Dampier Bunbury Natural Gas Pipeline (DBNGP)

REVIEW OF PROPOSED DBNGP ACCESS ARRANGEMENT (AA6) 2026 - 2030 (PUBLIC VERSION)

Report prepared for:
ECONOMIC REGULATION
AUTHORITY (ERA) OF
WESTERN AUSTRALIA

June 2025

Figure 6.12: Total IT infrastructure expenditure over the 15-year period from 2021 (sic) until 2030 – the effect of capex deferral

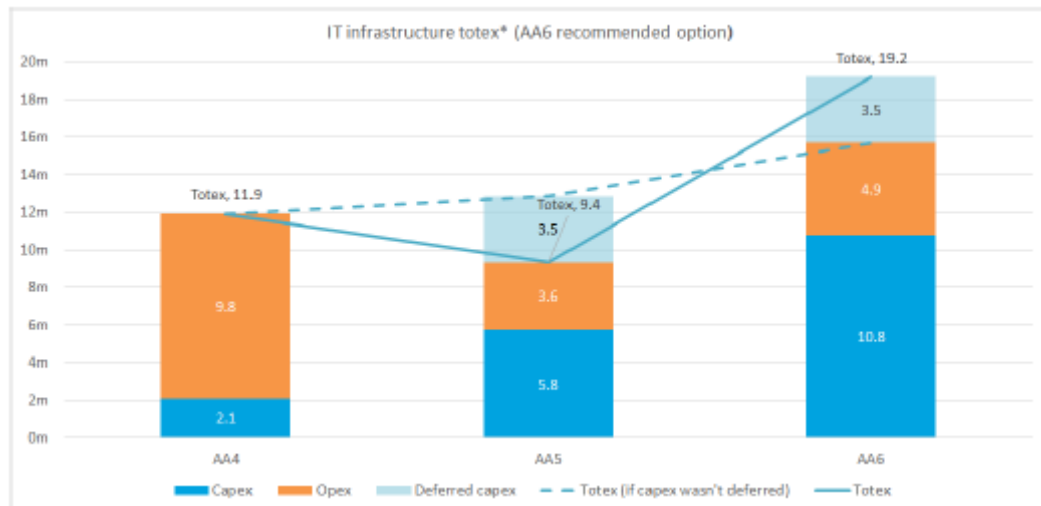
448. Given shifts in accounting policies for IT, there is merit in presenting IT infrastructure on a totex basis, rather than looking separately at capex and opex trends. DBP presents the figure that we have reproduced as Figure 6.12, in its business case.

450. We therefore tend to rely mostly on a 'totex trend' perspective and which suggests that, even taking account of a claimed refresh deferral from AA5 of the order of \$3.5m, the proposed AA6 totex of \$19.2m, as shown in Figure 6.12, is not a reasonable continuation of DBP's totex trend.

⁹⁶ DBP presents this as \$19.2m on the graph shown as Figure 6.12. We expect the small difference could relate to use of \$2024, escalation or rounding

Figure 6.15: Jandakot concept design – AGIG selected site layout

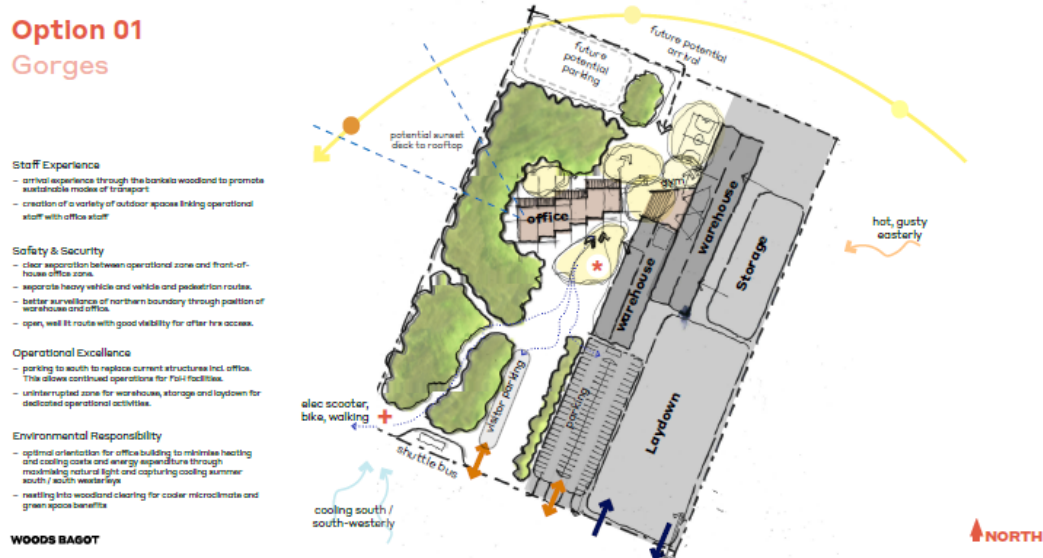
associated costing. We present excerpts from the concept design documentation in Figure 6.15 and Figure 6.16 below, as indications of the maturity of the design process.

Figure 6.18: DBP Proposed AA6 capex and EMCa adjusted - \$m, real Dec 2024

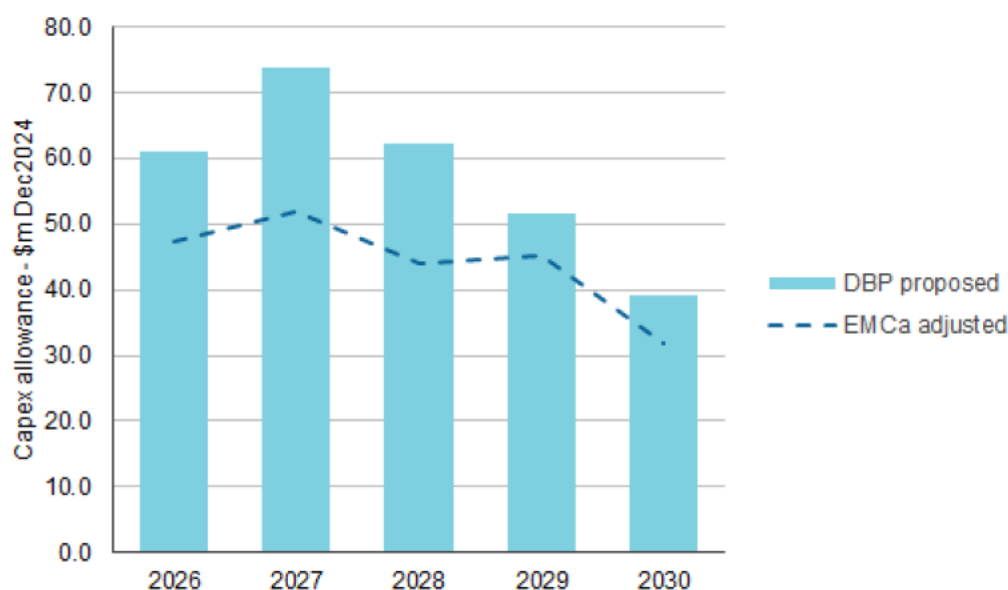
543. The following diagram shows the DBP proposed and EMCa adjusted capex forecasts for AA6, while in Table 6.31 we present the alternative forecast year by year, by asset category.

Figure 7.3: DBP actual salary costs compared with ERA allowances over AA4 and AA5 (to date) - \$m, real 2024

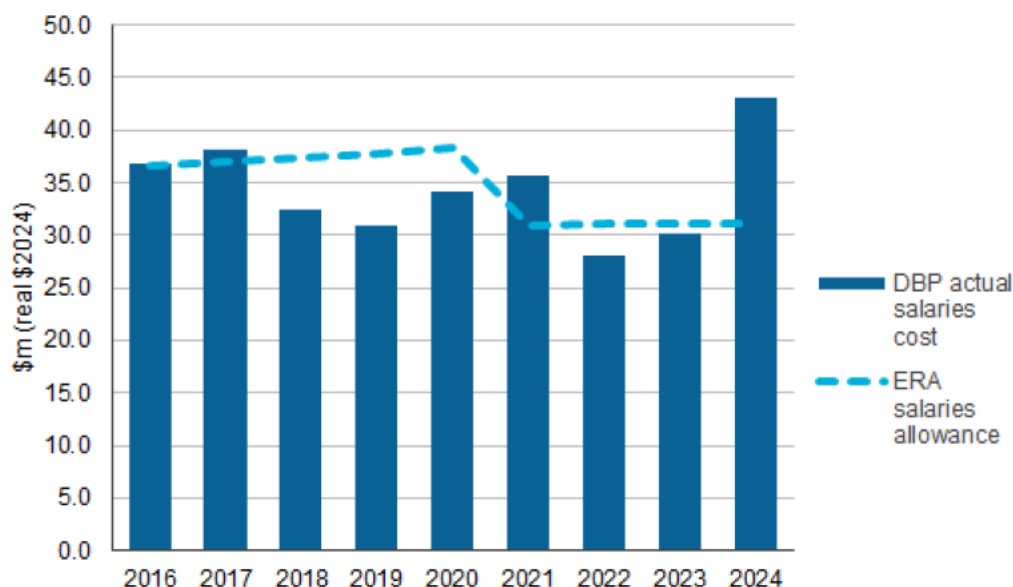
574. In Figure 7.3, which is drawn from the same historical data set used by BDO (but converted to real terms), it is clear that DBP has outperformed the ERA allowances in all except two of the previous eight years. However, to the extent that the ERA allowance is valid as an

efficiency benchmark, DBP's proposed basis for its AA6 allowance presents as a highly inefficient outlier. We consider it contradictory to present DBP as efficient on a historical average basis, but to then ignore the efficiency implication of DBP's proposed 2024 adjusted base year amount.

Figure 7.4: Employee cost breakdown and Staff Numbers

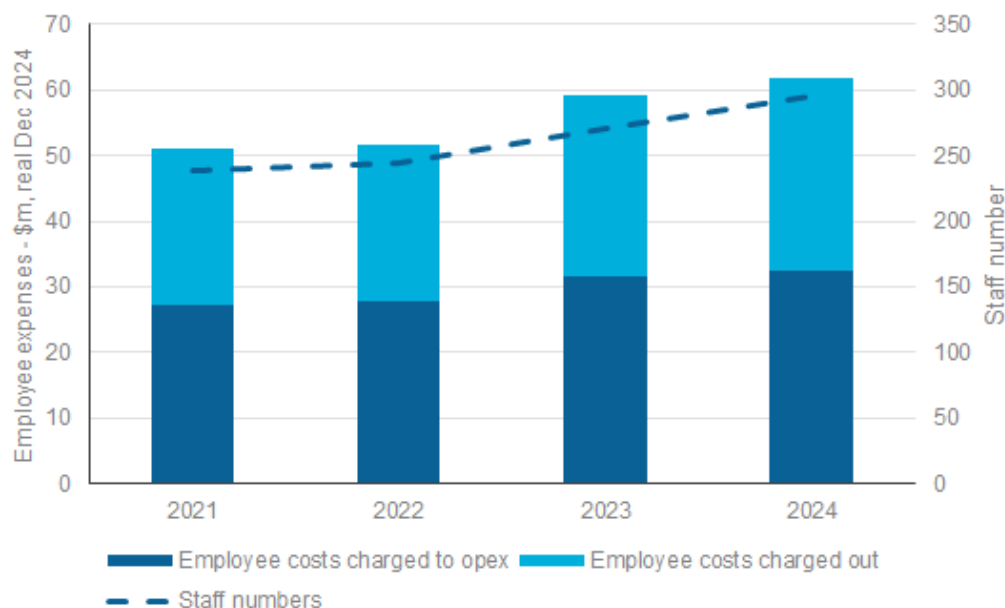
576. Figure 7.4 shows that the increase in staff numbers each year is almost entirely consistent with an increase in the employee costs charged out, once staff costs are recorded on the same accounting basis across each year, (i.e. before the proposed BDO adjustment in

577. In other words, from a DBNGP perspective, the increase in staff numbers over the recent period does not materially reflect increased requirements for DBNGP operations and management and, equally, any intentions that DBP has to further increase staff numbers does not justify an opex base year adjustment for DBNGP.

Figure 7.9: EMCa adjusted compared with DBP proposed AA6 and DBP historical trends - \$m, real Dec 2024

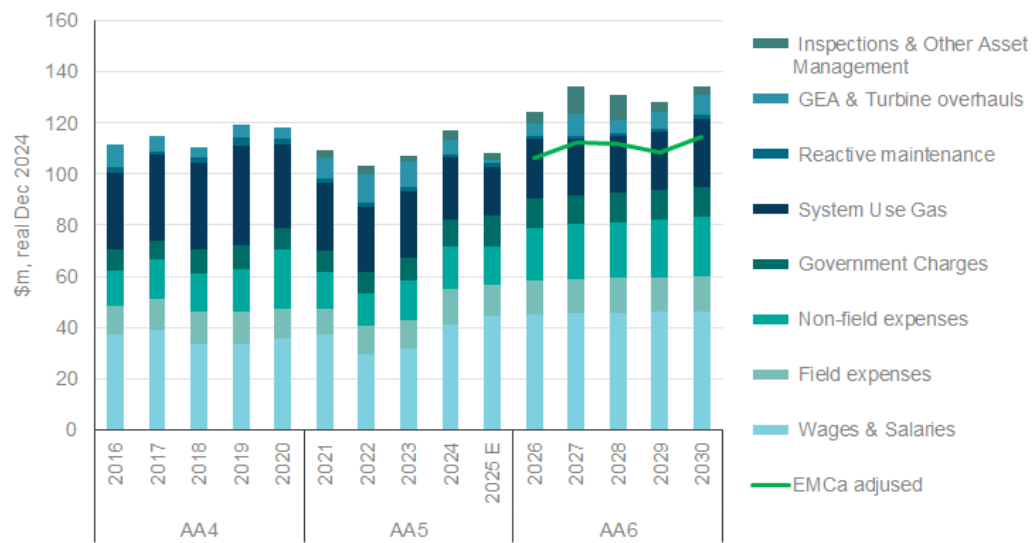
687. In Table 7.39 we present the resulting alternative opex forecast on a year-by-year basis and in Figure 7.9 we illustrate this by reference to DBP's long-term opex trend information.
